2 The Old Orchard, NW3 2TR ref. 2020/3293/P

Delegated Report		Analysis sheet	Expiry Date:	18/09/2020
(Members Briefing)		N/A / attached	Consultation Expiry Date:	11/10/20
Officer			Application Number(s)	
Jaspreet Chana			2020/3293/P	
Application Address			Drawing Numbers	
2 The Old Orchard London NW3 2TR			<i>Refer to decision notice</i>	
PO 3/4	Area Team Signature	C&UD	Authorised Officer Signature	
Proposal(s)				
External alteration to involve addition of staircase to rear elevation and addition of 1 rooflight to the front				
Recommendation:	Grant conditional planning permission			
Application Type:	Householder Application

Proposal: External alteration to involve addition of staircase to rear elevation and addition of 1 rooflight to the front

View from 1 The Old Orchard next to the proposed staircase.

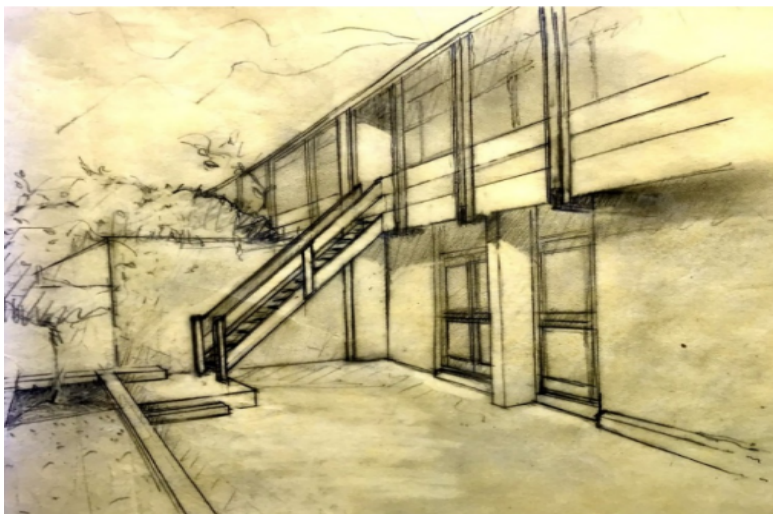
1) This mark is 6 feet high from the floor, which is on the low end of 'tall'

2) The balustrade is approx 2ft 10 inches tall

The entire first floor frontage, like Houses 2 and 3, is glass. It is also open plan, extending to the right, out of view of the picture into the kitchen and living area. Due to the design of the houses, a staircase built on the boundary of the two properties, next to the brick wall seen on the left, would have a wide un-obstructed view into the first-floor kitchen and living area. This factors in a reasonable, safe first step down. Have other locations been considered like a staircase from the existing large terrace from the first floor?

This photo was taken from a lower position and further away - it was not possible to get closer with the shed in the way. The figure viewable is 5 foot tall. At a closer and higher position, the view would be more exposed. The three houses (1, 2 and 3) were designed in the same way and have the same facade.

- Having looked at these photos, I am concerned that at the top of the staircase there will be direct sight into the first floor of the next door property. I don't understand their point about the "solid balustrade that runs along the balcony of the entire terrace" - surely if the stairs come out from the house, then they would be able to see in? Perhaps you understand what they mean by this?

- Following on my previous email, I have four follow up questions:
 1. Have the height and angles been calculated anywhere? The use of the word 'tall' is very vague (what does this mean?) and it's very difficult to understand the level of invasion of privacy without calculations.

4. The applicant has a terrace I understand, and so has opportunities to put the staircase elsewhere; have other positions been considered?
- Finally, the existing balcony is a long distance from the windows into the neighbouring property. The proposed location for the stairs would provide a new, wider and closer view, which isn't comparable.

- 4.3. Furthermore an objection has been received from/on behalf of occupiers at No.1, with further comments in relation to overlooking into their upper floor windows from the proposed staircase. From site photographs submitted with the application and those submitted by No.1 during the course of the assessment, it is considered a line of sight may be had towards the upper ground floor of No.1 but only when going up the stairs from the first step. There is no platform to stand and view into the neighbouring property for a significant period of time. Furthermore, given the wide solid balcony frame along the terrace it is considered this would further limit views into the neighbouring property when going up the stairs. Given this and the separation to the boundary, the stairs going directly down without a platform and general modest nature of the proposal it is not considered that the proposal would not have a detrimental impact on the amenities of No.1 in regards to overlooking or privacy impacts.
